RECOMMENDATION MEETING (#3034058-EG)

August 28, 2020

1766 NW MARKET STREET, SEATTLE, WA 98107

Construction of a new 85' eight story Type IV-C mass timber (CLT) hotel. With six floors of 120 upscale guestrooms, a double height CLT jewel box amenity at the ground floor with outdoor open space, a roof deck for hotel guests, and one floor of below grade parking with 30 stalls. The main hotel entrance will be located on the southeast corner of the site on NW Market St, and an outdoor dining area to the southwest. Access to the below grade parking levels will be from the alley to the North.

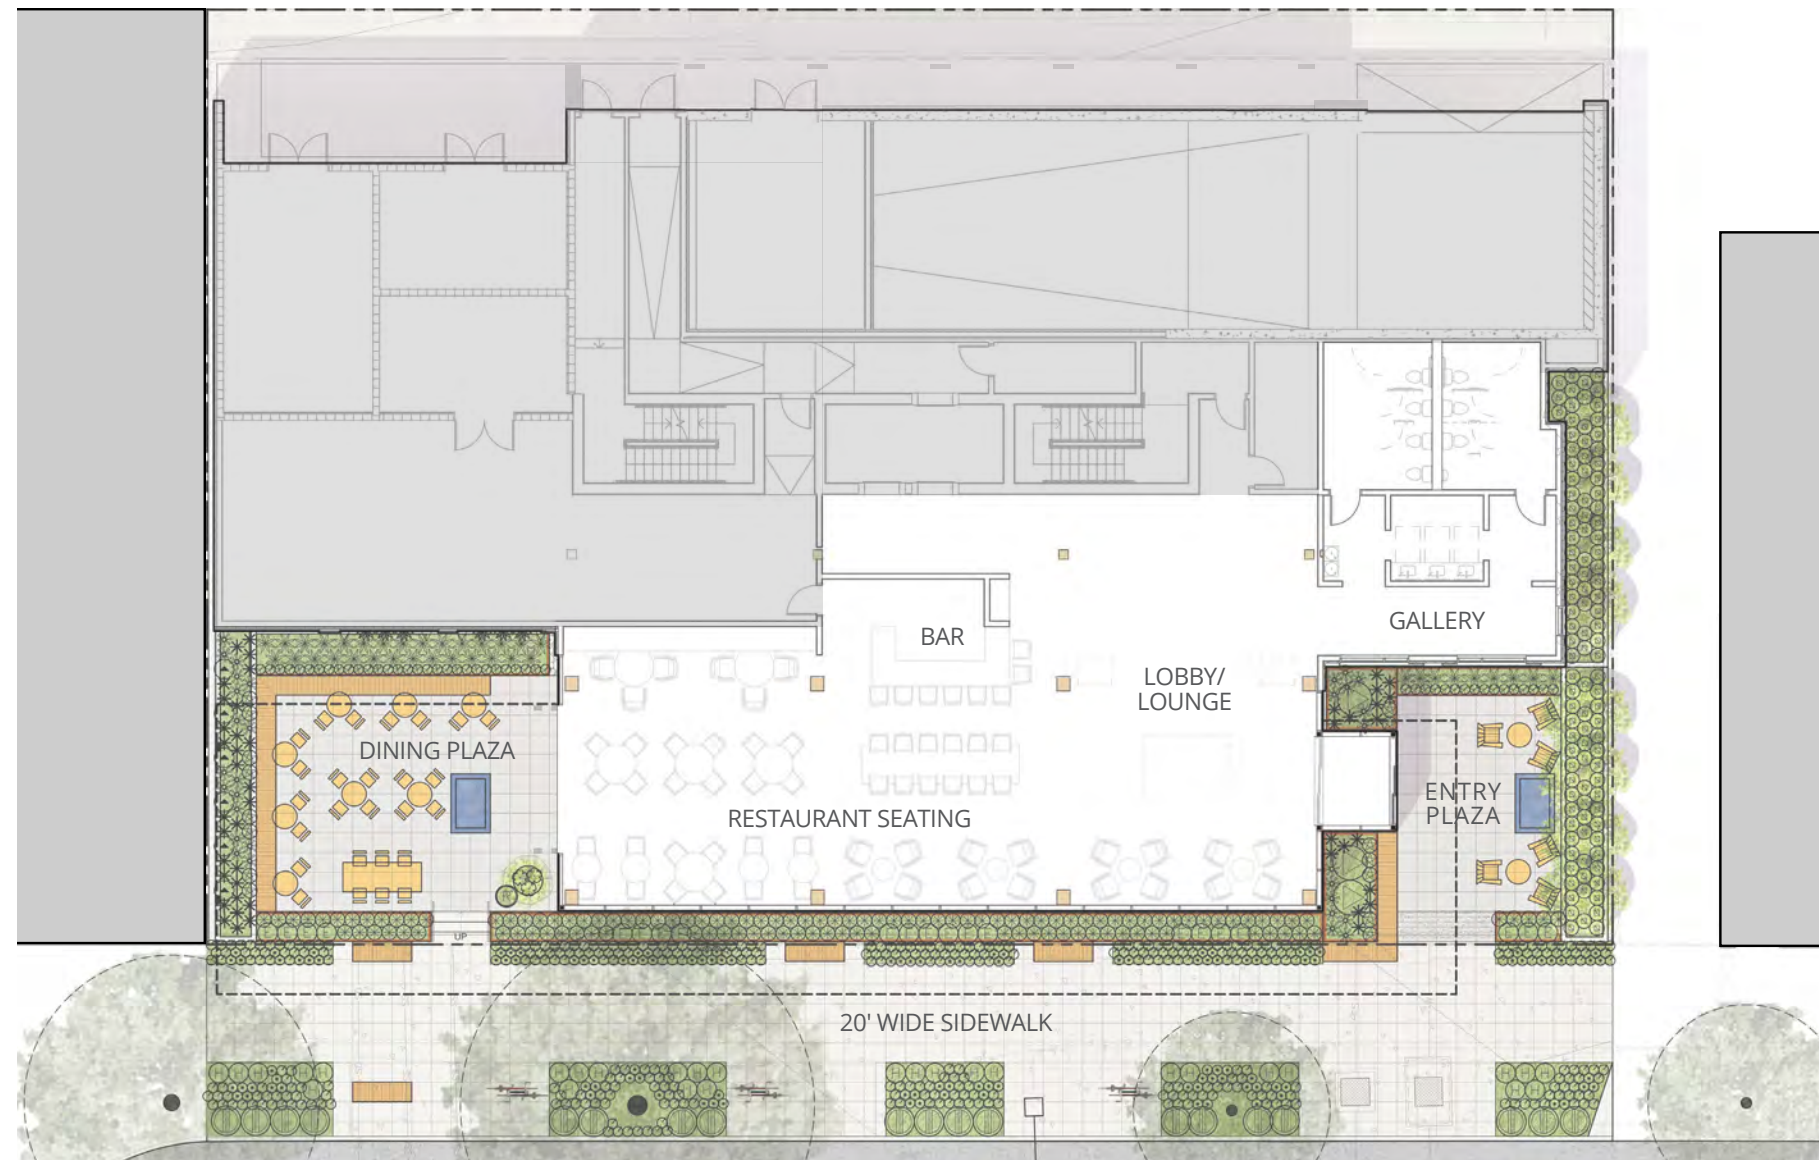
- BOARD GUIDANCE** | Demonstrate further refinement of the programming and allocate open space based on the proposed program. Clarify how the spaces will be used and the relationship to interior spaces, as well as the logic behind the distribution of area for the entry plaza vs. more public open space.
- INTERIOR/EXTERIOR FIT (DC3.A.1)** | Develop an open space concept in conjunction with the architectural concept to ensure that interior and exterior spaces relate well to each other and support the functions of the development.
- CONNECTIONS TO OTHER OPEN SPACE (DC3.B.3)** | Site and design project-related open spaces should connect with, or enhance, the uses and activities of other nearby public open space where appropriate. Look for opportunities to support uses and activities on adjacent properties and/ or the sidewalk.

RESPONSE | The ground level along Market Street is divided between the glassy, double height CLT jewel box and plazas to the east and west. To the east, the entry plaza leads directly to the reception area, and to the west, the outdoor patio seating blends seamlessly with the interior restaurant seating. The landscaping, seating, canopies, and finishes will continue across the divide between inside and out, giving the spaces a unified expression. The dining plaza is larger than the entry plaza to reflect the best use of where people can gather and socialize, versus pass through more efficiently. The building massing of the lower levels and the sidewalk canopy aligns with the two adjacent buildings, creating a continuous, unified street edge expression along the Market Street.

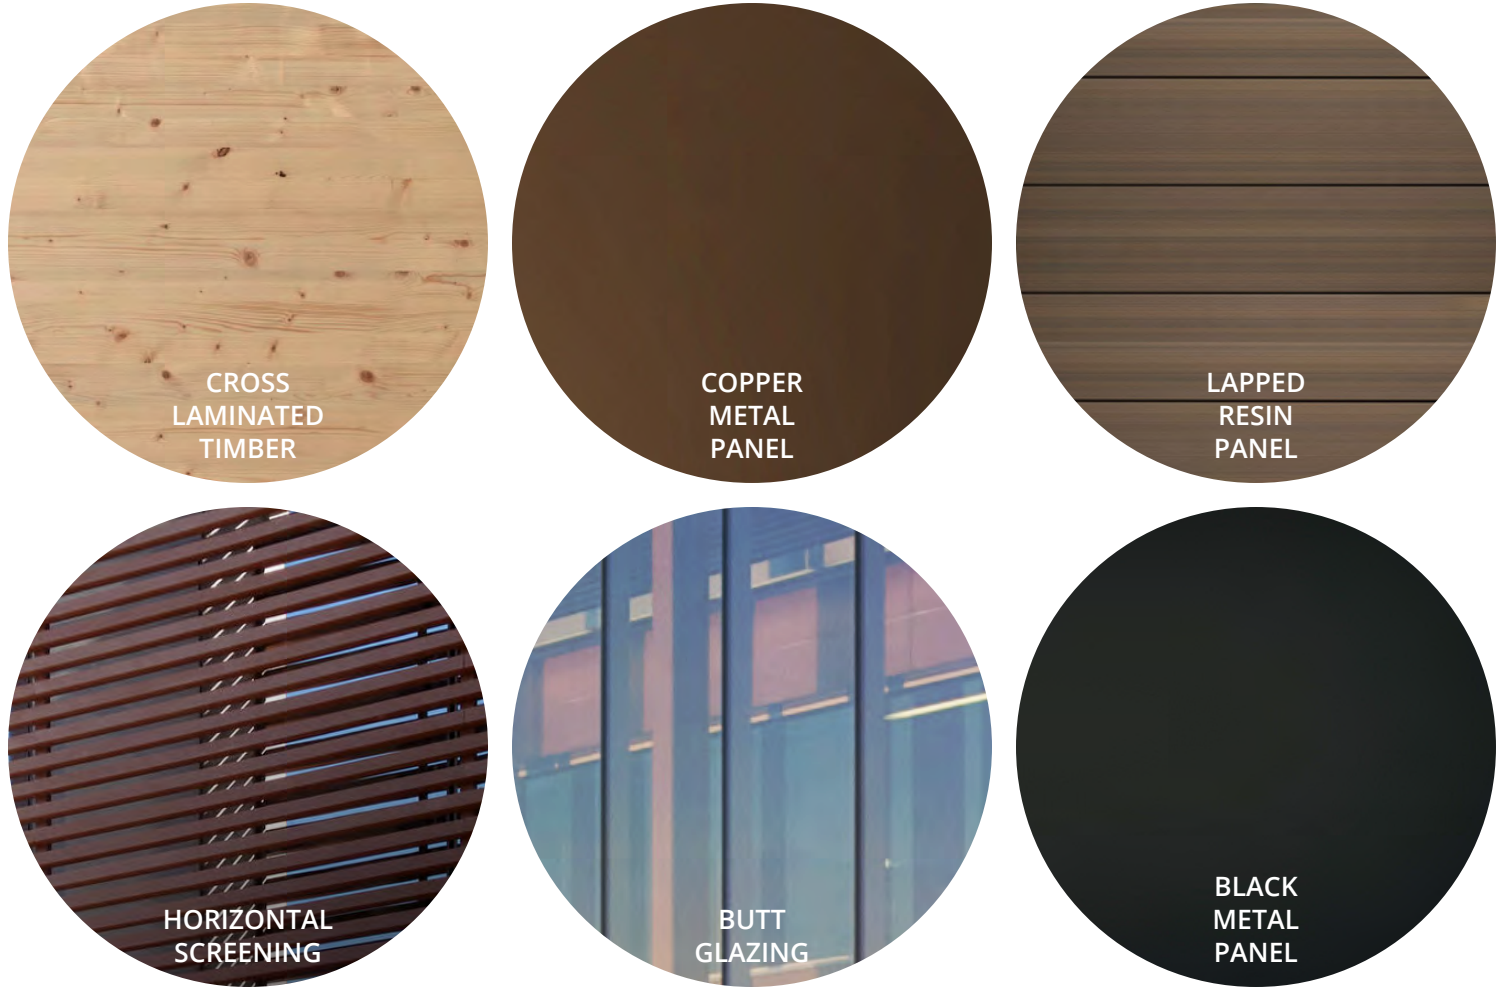
- BOARD GUIDANCE** | The board noted the proposed exterior palette should relate back to the warm interior materials (exposed CLT), as well as adding the warm texture throughout the open space.

RESPONSE | The expression of mass timber is warm and elegant, so we're keeping our material palette straightforward and refined - simple, consistent, large windows with dark frames, surrounded by repeated sections of finely textured lapped resin panel, all within a field of copper-toned metal panels. This palette has the added quality that, in addition to feeling solid when viewed from a distance, the materials get more and more interesting the closer you get to the building, further drawing pedestrians into the plazas and interior. Because our material choices are restrained and complimentary, it works well with the current smaller scale of the existing context.

SOUTH FACADE ARTICULATION

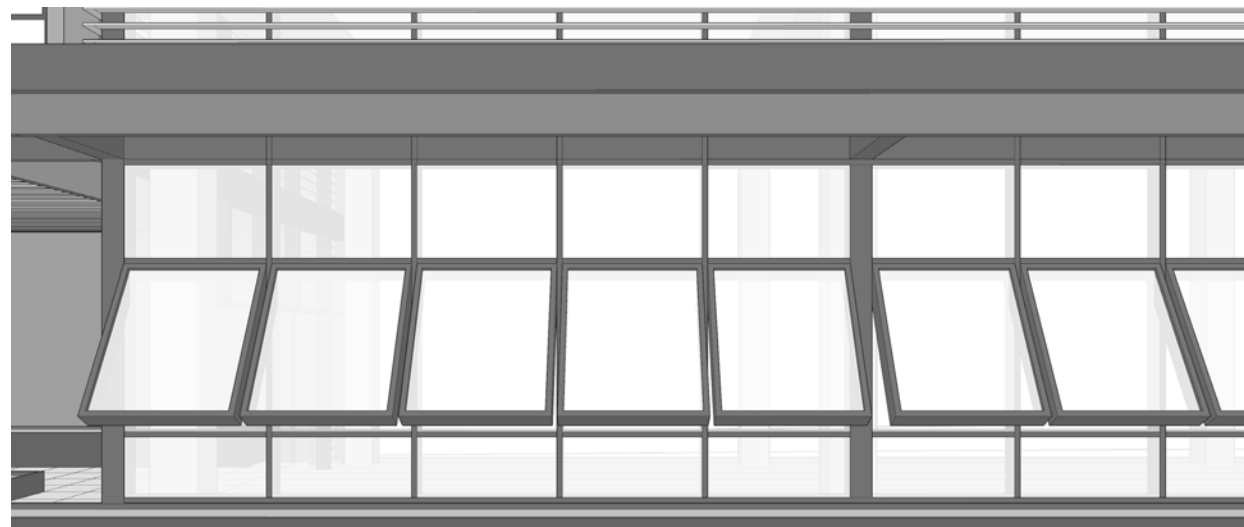
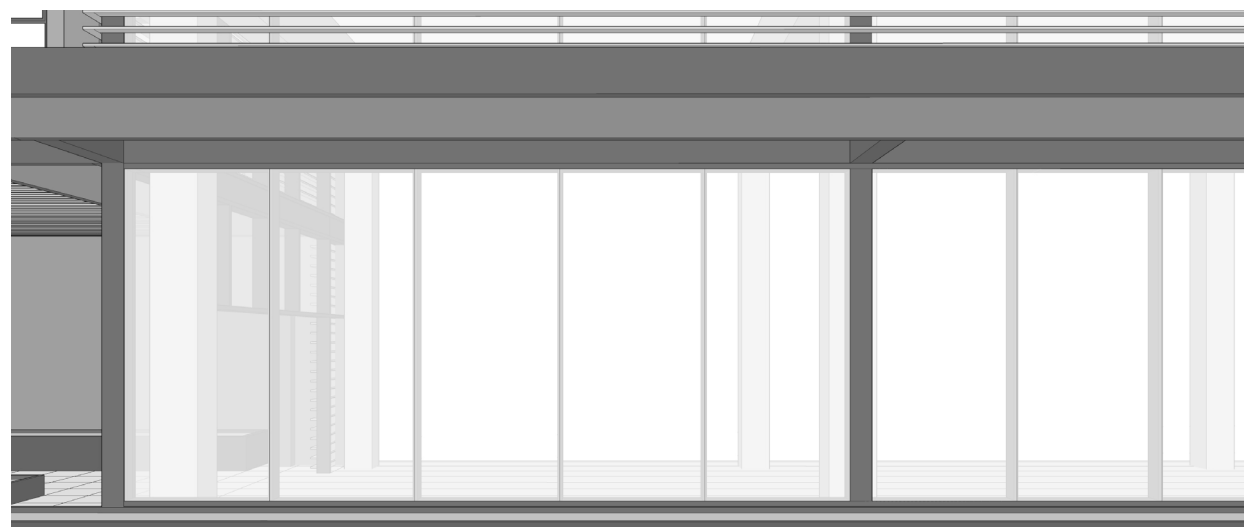
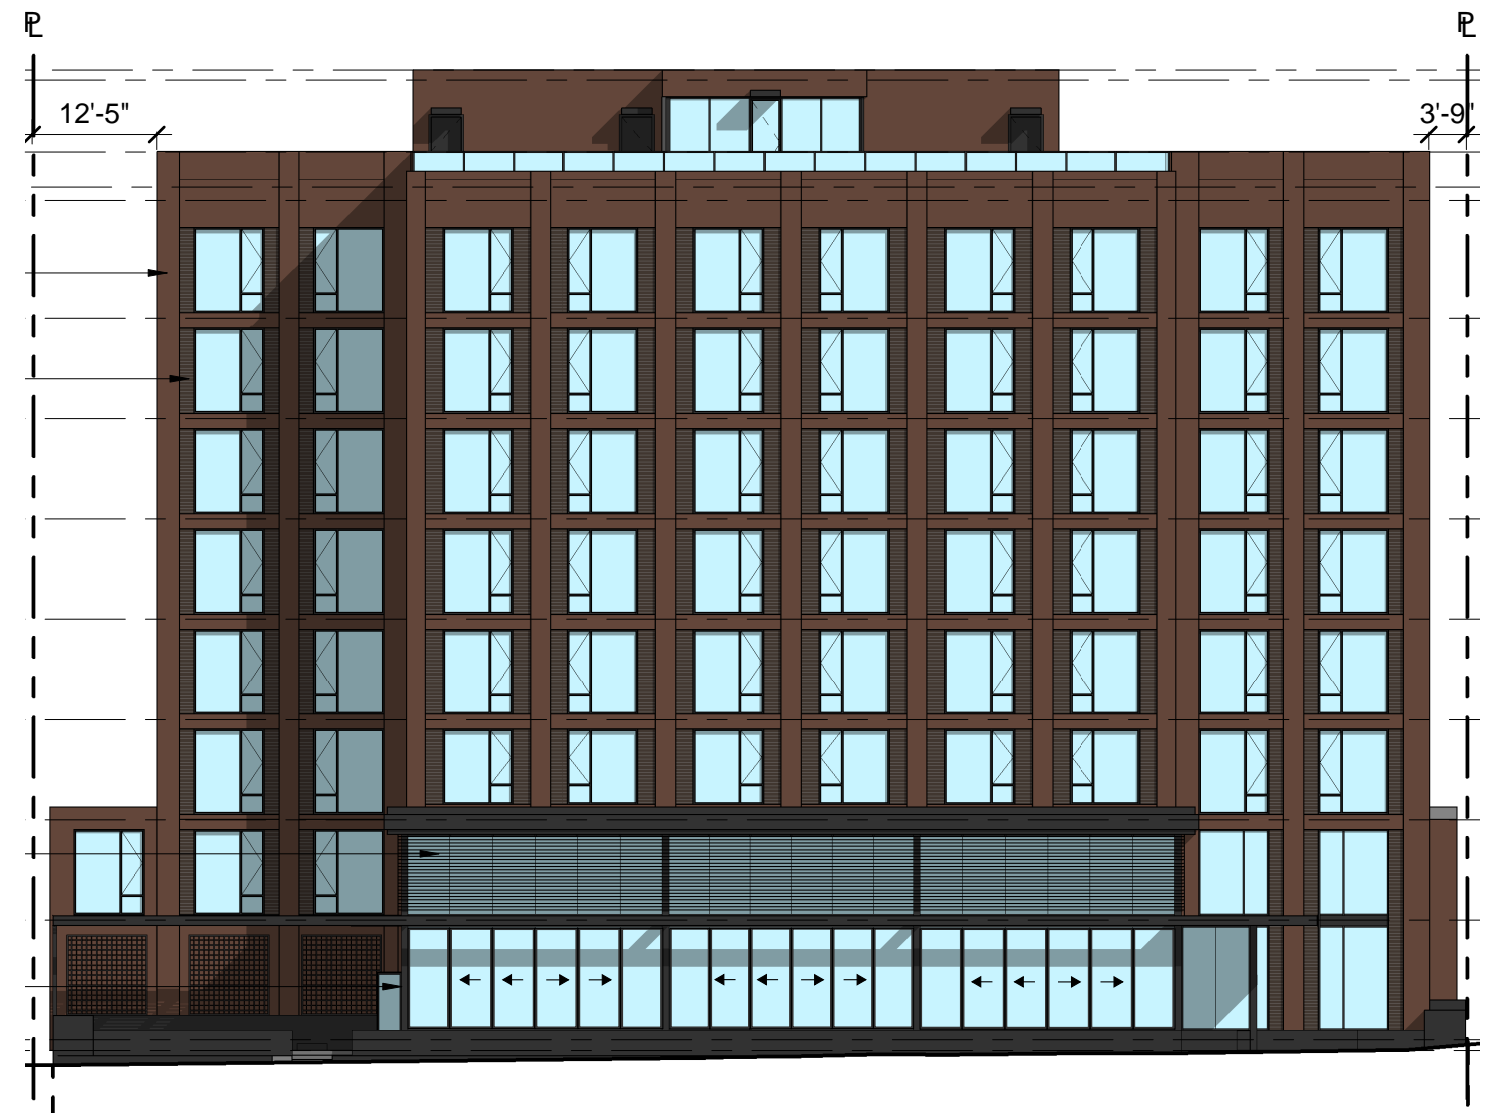
BOARD GUIDANCE | The board supported the potential for operable storefront systems to further animate the street.

RESPONSE | In order to highlight the visibility from the interior amenity space to the sidewalk, we're maximizing the ratio of glazed surfaces to mullions by using a high-quality butt-glazed system instead of a typical stick-framed system. This will also maximize the visibility of the mass timber structure within the building. We plan to use an operable storefront system along the west facade of the jewel box to more seamlessly combine the plaza and indoor amenity space.

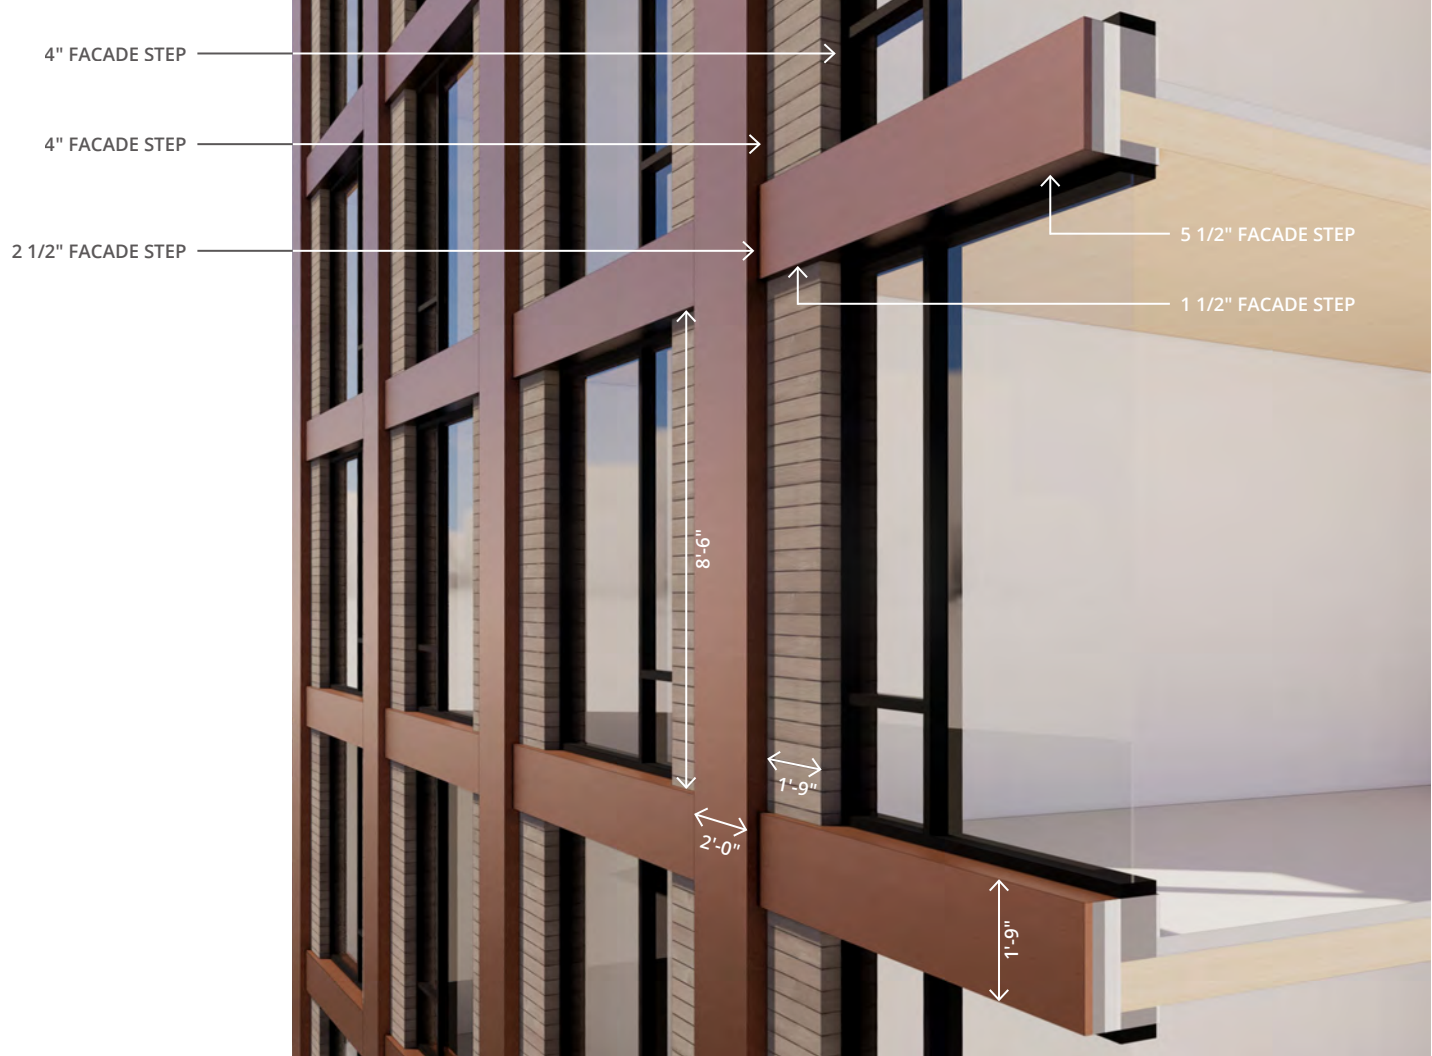
- BOARD GUIDANCE** | Supported CLT being expressed at the street-level (lowest 2 floors). The board would like to see the next level of detail, providing more clarity on the facade articulation and clarification of how the proposal is relating to the contextual storefront / street-level character. The board commented that they understand CLT has the potential to express the storefront character in a new way, perhaps through dimensions / proportions that showcase the dimensional abilities of CLT structural system.

RESPONSE | CLT structural systems embed true material quality deep into a building, instead of being merely a veneer applied to a substrate. This naturally invites the massing and exterior materials to simplify, to better highlight the simple geometry of the mass timber inside. At the base of the building, the glazed facade allows the structure to be seen from the street. In the rest of the building, the material alignments and detailed articulation reflect the simple CLT structural grid on the inside.

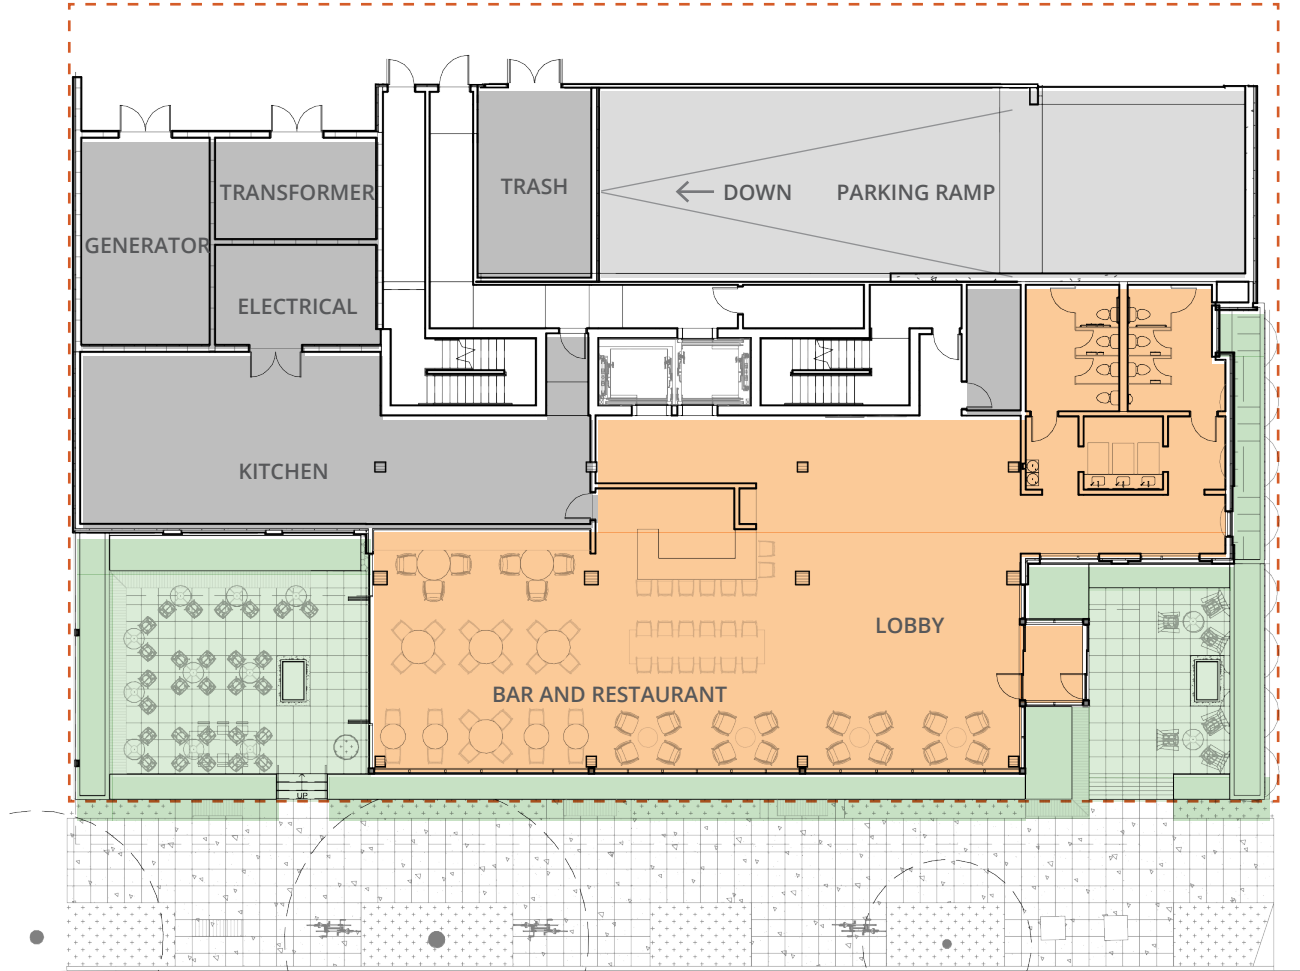
BOARD GUIDANCE | Lighting for outdoor spaces and along the alley should be designed to minimize light pollution to adjacent residential windows.

RESPONSE | We're proposing to use downlighting in all outdoor plazas and along the alley to minimize their impact on the adjacent residential developments opposite the alley to the north, and on the commercial buildings to the east and west. Reducing light leakage will also reduce ongoing energy use. We're also proposing high-quality downlighting along the Market Street sidewalk highlighting the landscaping and seating, to enliven and make the sidewalk safe at night.
